CLINTON CITY PLANNING COMMISSION AGENDA ITEM

SUBJECT: 7:10 p.m. Public Hearing – Preliminary Plat Stone Subdivision - Review and action upon a request for approval of the Preliminary Plat of Stone Subdivision, located at approximately 3420 West on the south side of 2300 North.	AGENDA ITEM:
PETITIONER: Jeffrey Kuhn, Stone Family Trust and Alan Cottle, Cottle Capital Group,	MEETING DATE: August 4, 2015
ORDINANCE REFERENCES: Subdivision Ordinance Zoning Ordinance Chapter 12	ROLL CALL VOTE: YES NO
BACKGROUND: <ul style="list-style-type: none"> ▪ The 2013 Clinton City General Plan, Master Land Use Map, indicates this area of the City is planned for acre lot development. ▪ The property is Agricultural Zone (A-1). ▪ The preliminary plat indicates development as an A-1 development. ▪ The lot sizes meet the minimum requirement but there are lots that do not appear to have minimum frontage, Lots 13 and 20. I have requested that the frontage measurement be provided for lots 12,13, 20 and 21

SUBDIVISION REVIEW

REFERENCE: Stone Subdivision Preliminary Plat Submittal July 17, 2015

PRELIMINARY GRADING, DRAINAGE AND UTILITY

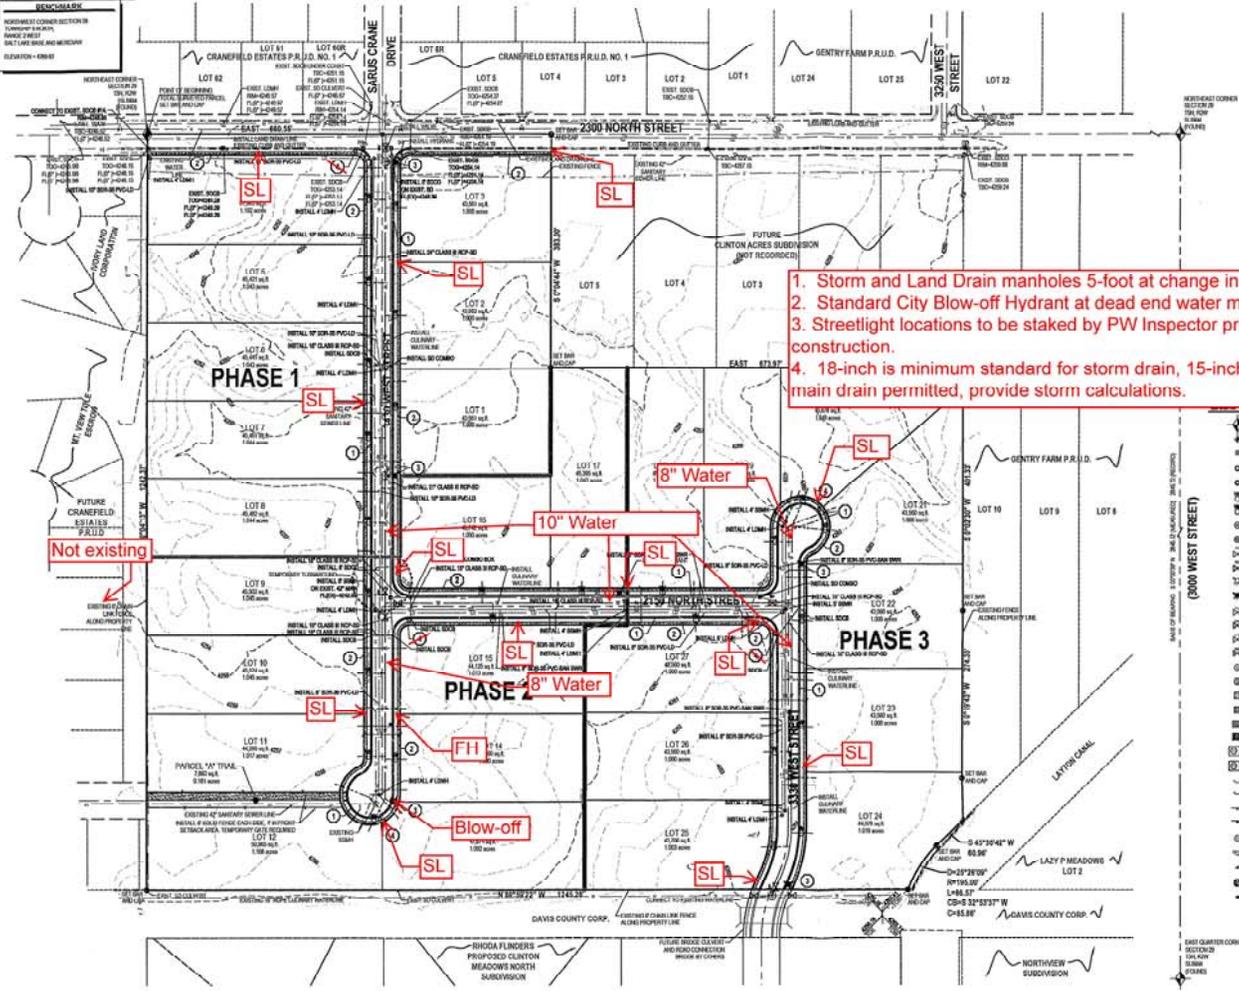
1. Storm and Land Drain manholes 5-foot at change in direction.
2. Standard City Blow-off Hydrant at dead end water mains.
3. Streetlight locations to be staked by PW Inspector prior to any footing construction.
4. 18-inch is minimum standard for storm drain, 15-inch from CB to main drain permitted, provide storm calculations.
